2 December 2010
E&L-108-10

SUBJECT: Response to RAI dated October 26, 2010
Re: Request for Amendment of US Nuclear Regulatory Commission
Certificate of Compliance No. 9204 for the Model 10-160B Shipping
Cask, E&L-037-10, 2 April, 2010
Docket No. 71-9204
TAC No. L24435

CONSOLIDATED SAFETY ANALYSIS REPORT

MODEL 10-160B

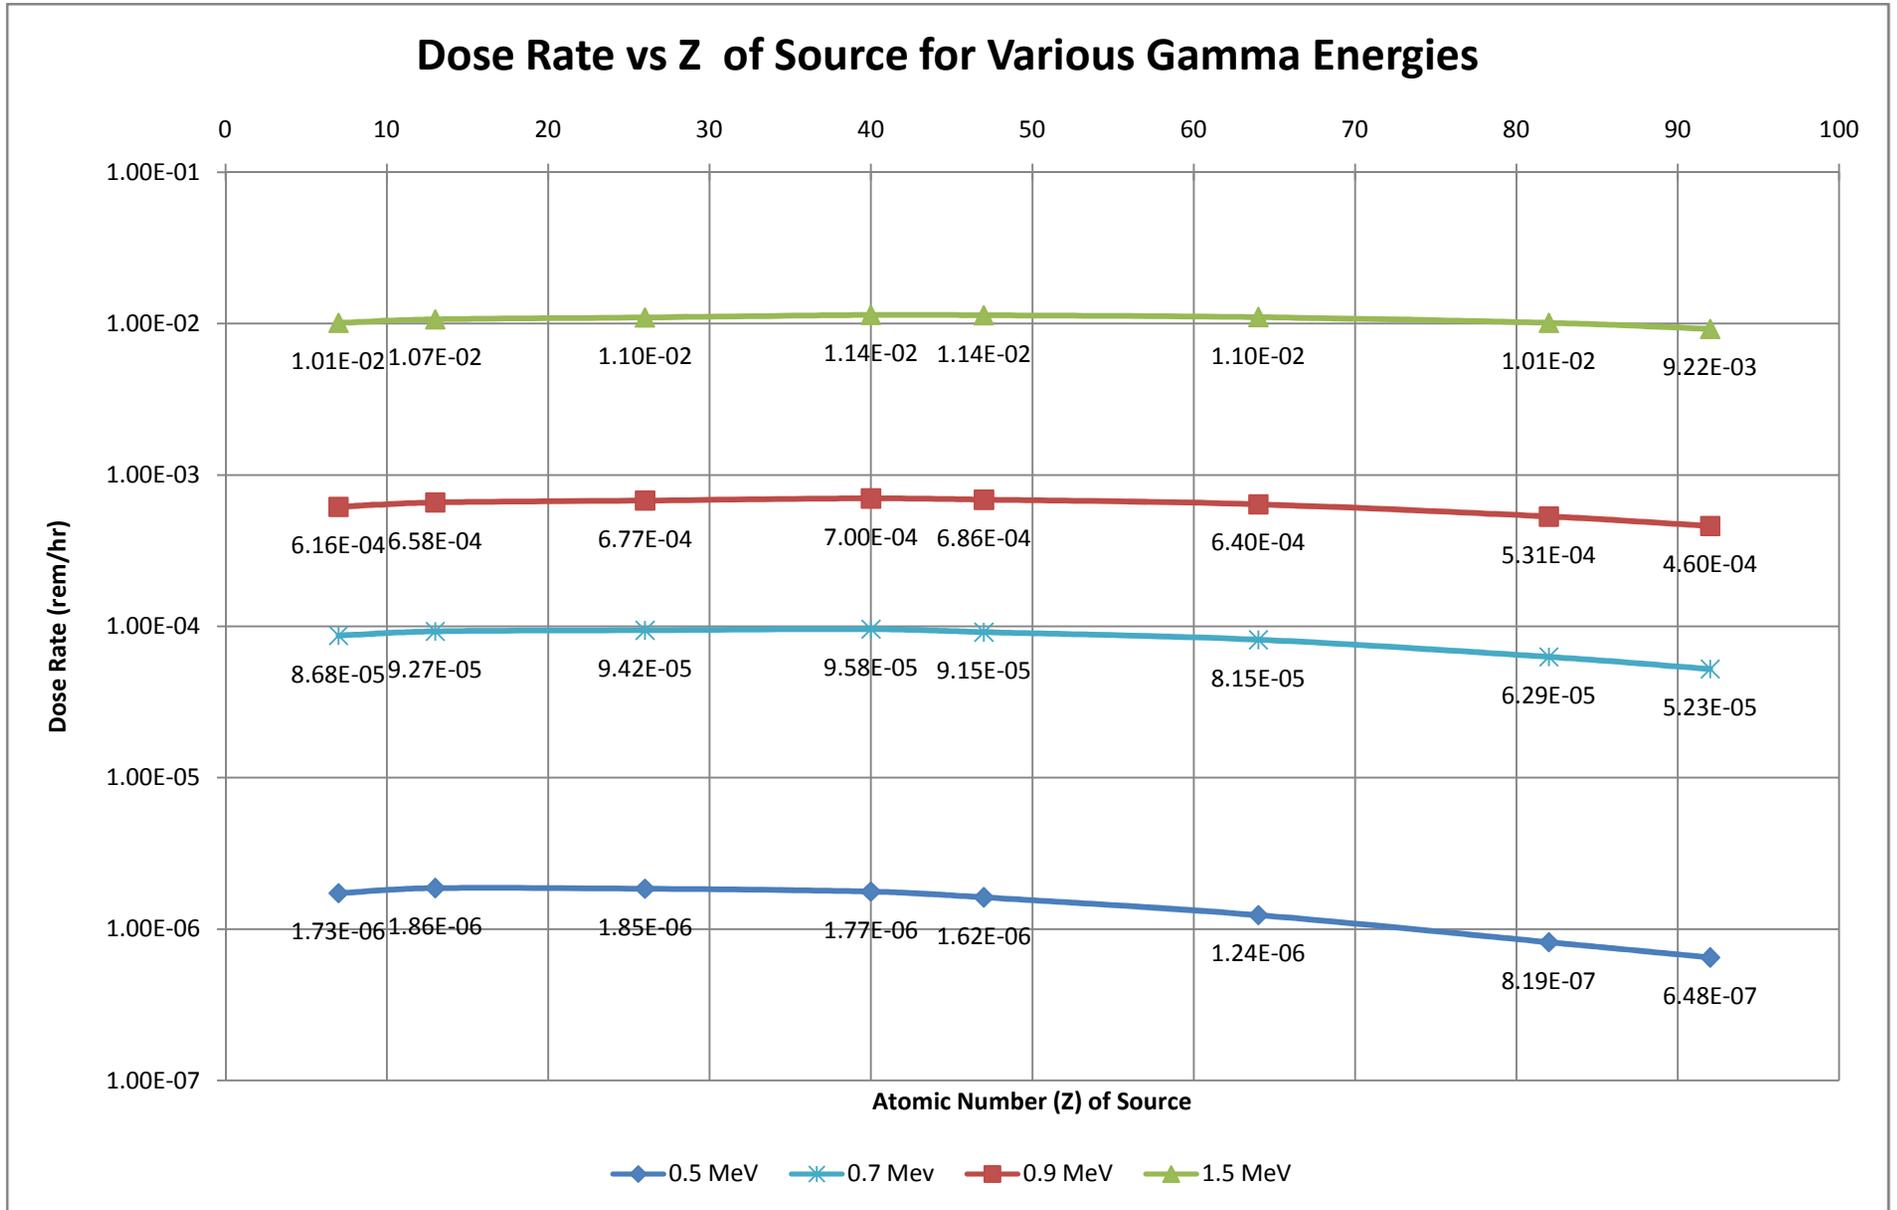
Demonstrate that using z=40 as the material of the content produces conservative results for gamma sources in all energy range

Section 5.5 of the SAR states: "The material of the source was selected as Zr (z=40); multiple calculations with various materials showed a material selection of Zr was conservative." Provide the information used to determine that z=40 is the most conservative content for the dose calculations. Be sure to include what energy range of the photons was used in this study for gamma radiation and explain why this result is appropriate for gammas in both high and low energy ranges because the gamma attenuation through materials is highly dependent on the energy of the particles.

Contact dose rates were calculated for a distributed source that fills the cask cavity and is at the cask content weight limit, i.e., $r=86\text{cm}$, $h=194\text{cm}$ and $\rho=1.46 \text{ g/c}$. The composition of the source was varied over a range of materials with different atomic numbers (Z values) from 7 to 92. The gamma energy was varied from 0.5 MeV to 1.5 MeV. The dose rates at each energy are plotted versus the Z of the material. The plot shows a Z=40 (zirconium) is conservative, i.e., gives a larger dose rate for all energies except for 0.5 MeV. Since gammas of 0.5 MeV and less do not contribute significantly to the cask external dose rates, the use of a Z=40 for the source is appropriate.

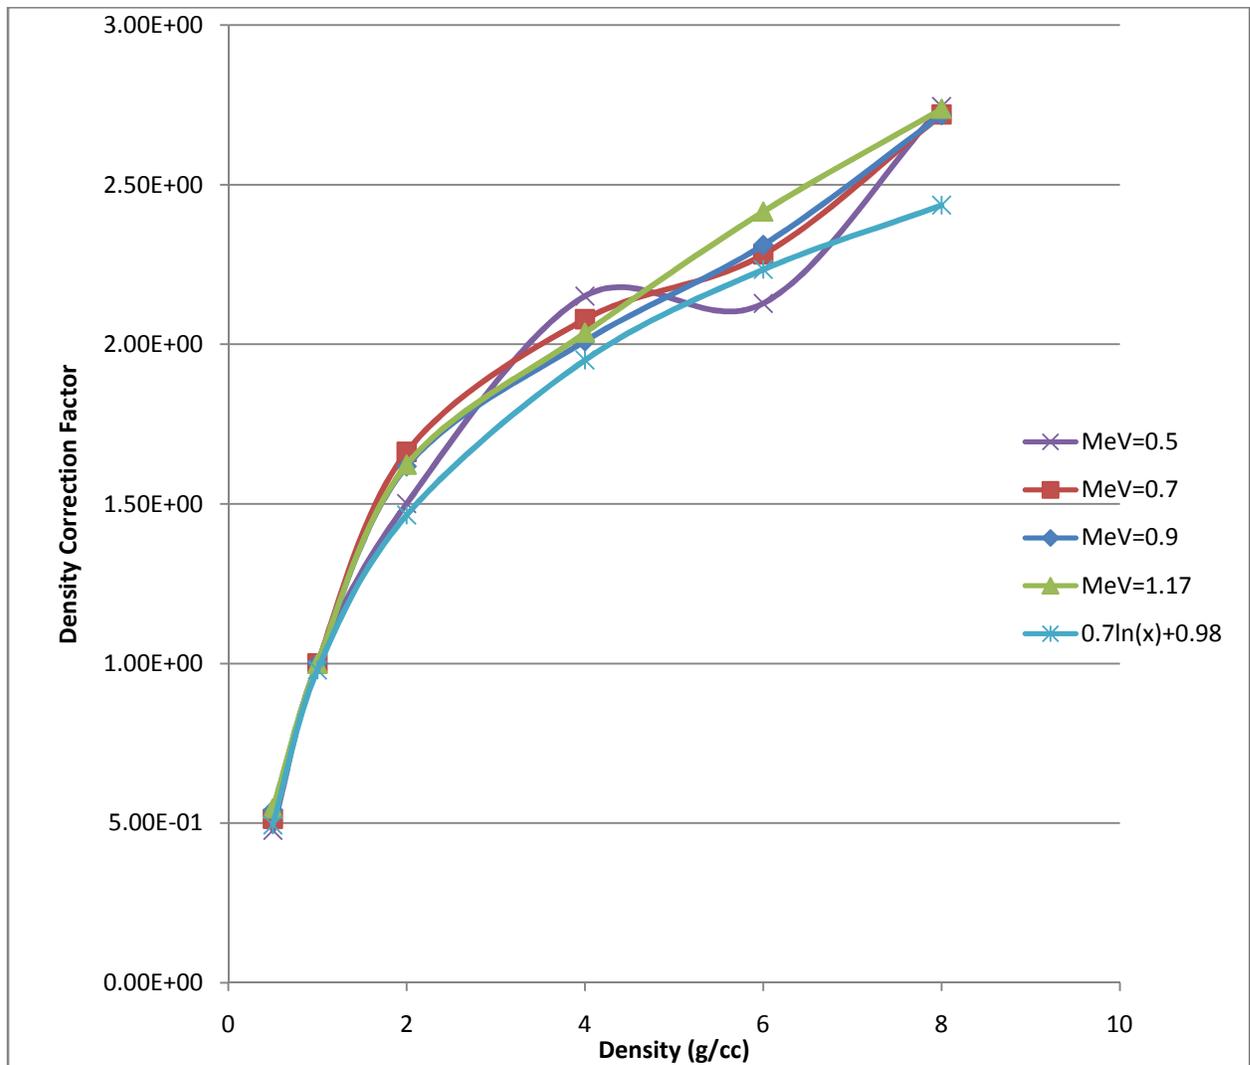
Justify the use of the Density Correction Factor (DCF) for gammas with energy other than 0.9 MeV.

The equation for the DCF was determined using 0.9 MeV gammas. The staff believes that gammas of higher or lower energy would have different attenuation through varying density material. A higher percentage of lower energy gammas would tend to be stopped than the higher energy gammas. Therefore the staff does not find that the DCF equation would necessarily be applicable or bounding for gammas of other energy. Justify that this equation is applicable or bounding for gammas of all energies that are to be stored in the 10-160B.

The SAR also states that the geometry was changed when performing these density studies. Provide additional information on how exactly the geometry has been changed.

Additional SCALE calculations were performed over a range of energies to determine the applicability of the DCF equation at different energies. A plot of these results is shown below. To incorporate the results at the range of energies, a new equation was fitted to the data and then adjusted to give conservative results except over a small density range for energies of 0.5 MeV. The equation of the adjusted fitted line is shown on the plot, $DCF=0.7\ln(x)+.98$. Since most distributed sources transported in the 10-160B will have a bulk density less than 4 and energies over 0.5, the small range of non-conservative values is not significant. The equation of the adjusted fitted line will replace the equation previously provided as the DCF.

As stated in Section 5.5 for the configuration of the distributed source, the geometry is adjusted with the density of the material such that “ $H=2r$ (approximately the geometry of the cask cavity) and $V_p=14,500$ lbs (maximum allowed weight of contents)”, with the constraint that the source cannot exceed the cavity size. This configuration specification is used in the determination of the DCF, i.e., as the density increases the volume of the source is reduced.

Figure 5.4 – Density Correction Factor

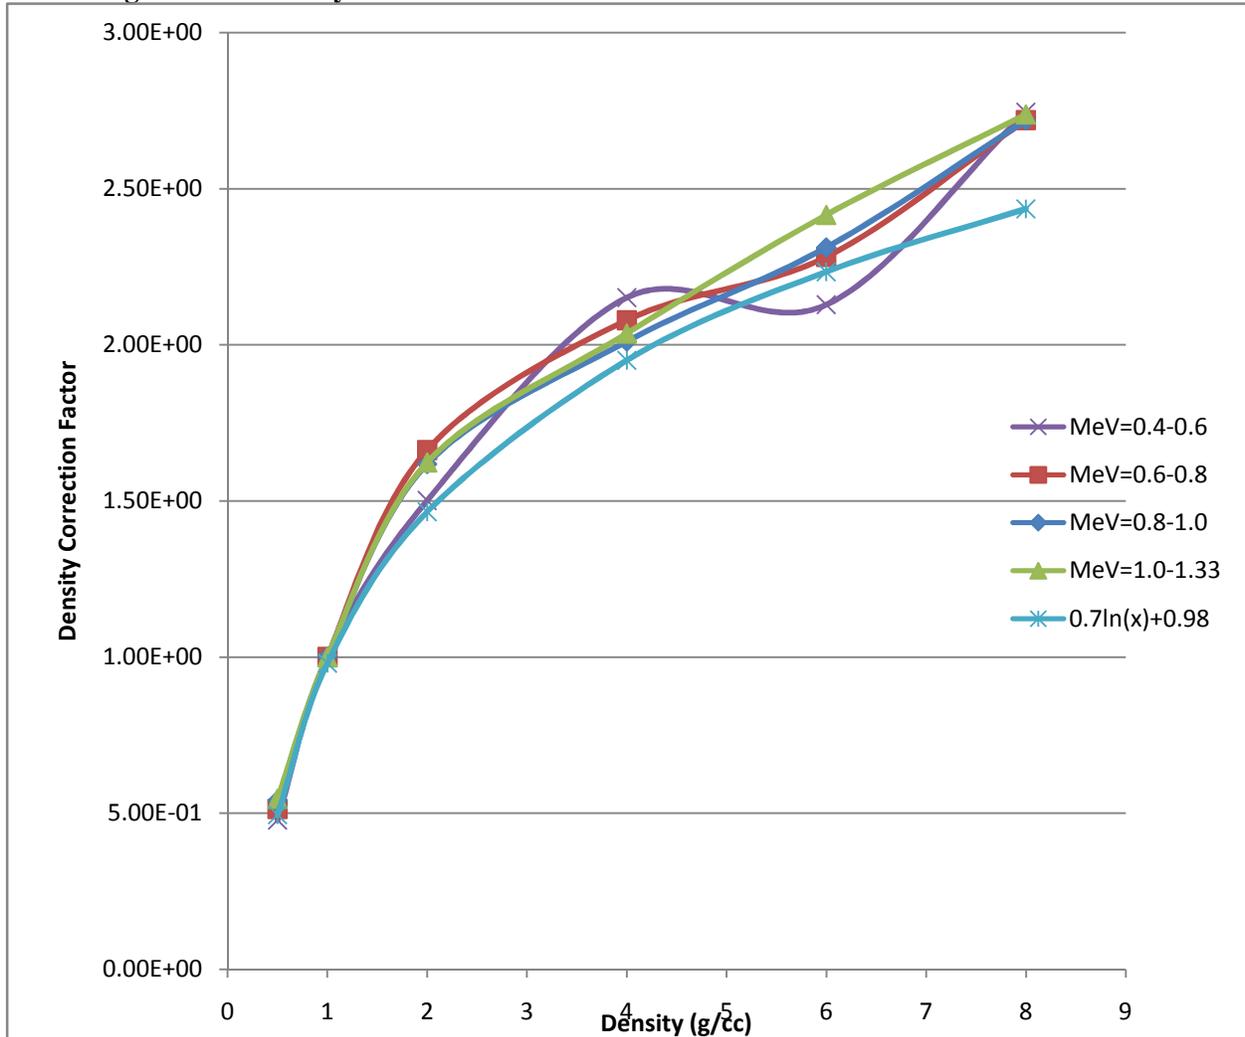
Revise the methodology for Step 6 in Attachment 1 to Chapter 7 of the revised SAR to explain how the Density Correction Factor (DCF) will be calculated in the source density is less than 1 or greater than 8 g/cc..

The equation for DCF used in Step 6 is based on a curve fit for calculations performed in Table 5.8 for the DCF as a function of the source density. However, the minimum and maximum density used in these calculations was 1 and 8 g/cc, respectively. Explain how DCF will be used in this methodology for source densities less than 1 and greater than 8 g/cc.

The revised DCF curve, discussed in response 5-3, extends to density of 0.5 g/cc. Examination of the curves provided in response 5-3 indicates that the DCF curve matches the shape of plotted density calculation results and is especially conservative at 8 g/cc. It is appropriate to use the equation for densities both above and below the density values plotted.

$$DCF = 0.7\ln(\rho)+0.98$$

Figure A-1 – Gamma Activity Limits

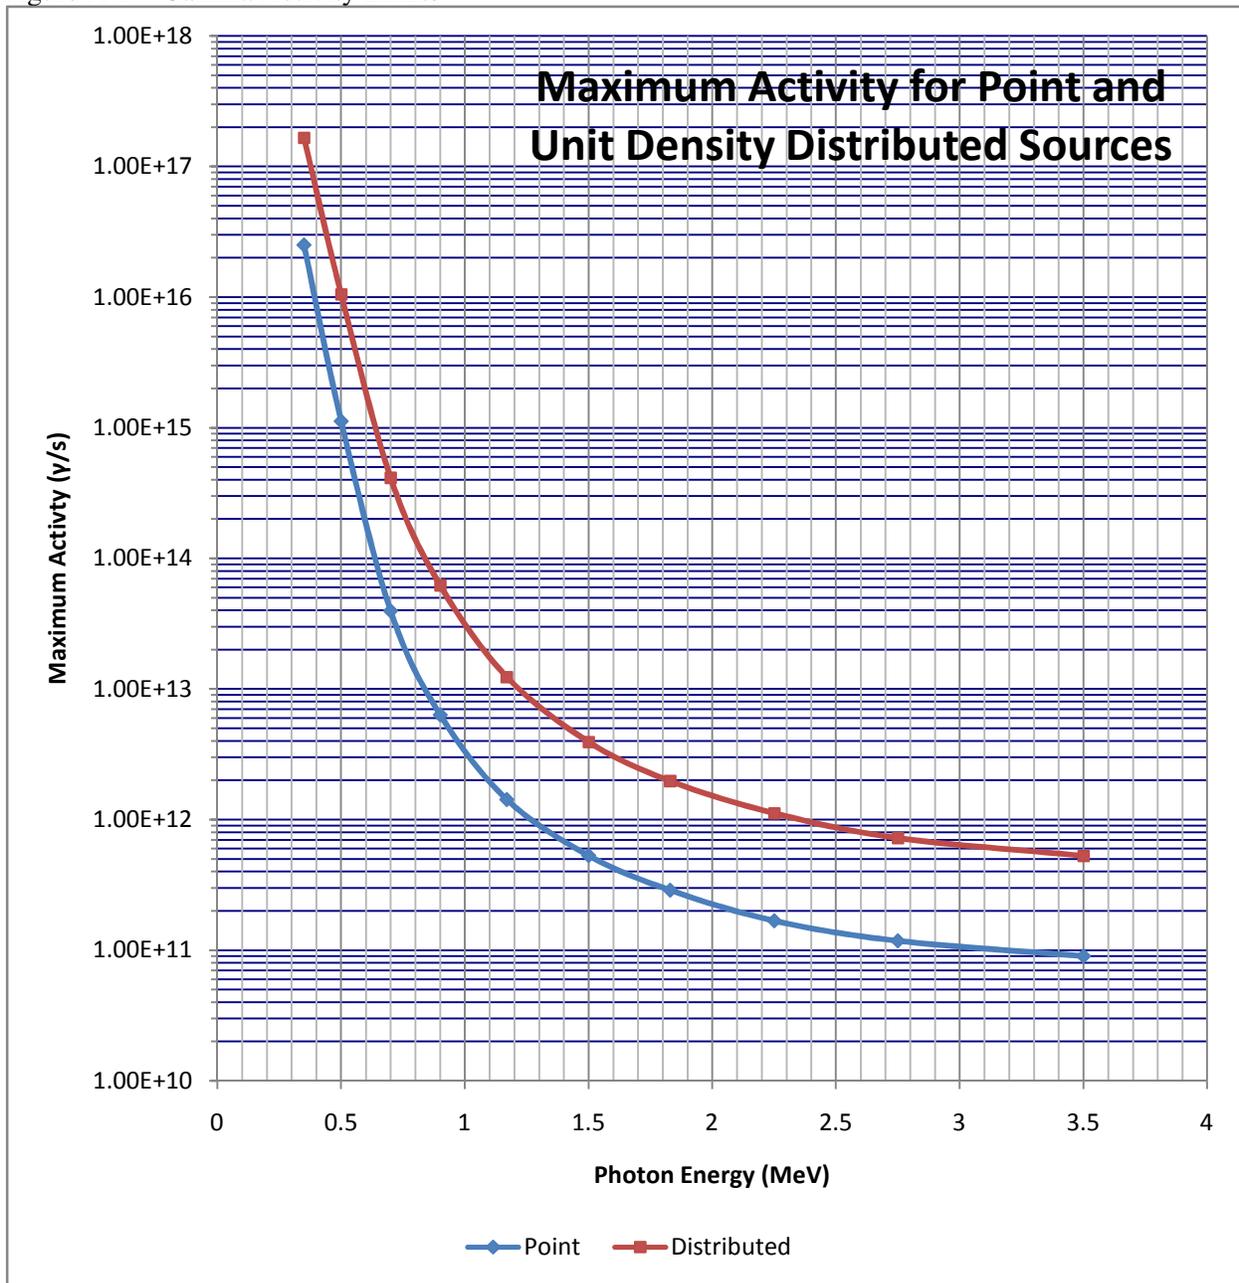
RAI 5-1

Demonstrate it is appropriate to reduce the SAS4 calculated dose rates by a factor of two for the 10-160B package shielding analysis

In addition, reducing the calculated dose rates by a factor of two causes a self-inconsistency in SAR. The staff used 13.4 Ci of Co-60 as a sample problem to check how this methodology works. The results seem to indicate that the data found from these curves produced 200% of the allowable content.

Based on the information provided in page 5-2 of the SAR and the examples in Attachment 1 of the SAR, the maximum allowable Co-60 source is 13.4 Ci. Since Co-60 gives two photons, 1.17 MeV and 1.33 MeV, per decay, the total number of photons from the 13.4 Ci source is 4.96×10^{11} ($13.4 \times 3.7 \times 10^{10}$) for each energy group. From the curve in Attachment 1 of the SAR, the corresponding

maximum radiations from these two gammas are 2.98×10^{12} γ/s and 1.7×10^{12} γ/s , respectively. Thus, the fractions of the 13.4 Ci of Co-60 for the two photons in these two energy group are:

$$4.96 \times 10^{11} / (2.98 \times 10^{12}) = 0.166, \text{ and}$$

$$4.96 \times 10^{11} / (1.7 \times 10^{12}) = 0.292, \text{ respectively.}$$

The total fractional radiation source is 0.458. From page 5-2, it is understood that 13.4 Ci of Co-60 is the source loading limit for the packaging design; based on the description of the methodology, the fraction of the total source load should be very close to 1.0 rather than 0.458. Therefore, using the methodology and the curves in Chapter 7 to determine the maximum Co-60 source that can be shipped will exceed the design basis source described in Section 5.2.2 of the SAR.

The factor of two (2) correction factor has been removed from the calculation and the gamma dose limit curves adjusted accordingly. This change has been incorporated in the revised Chapter 5 and Chapter 7 which are included with this submittal.
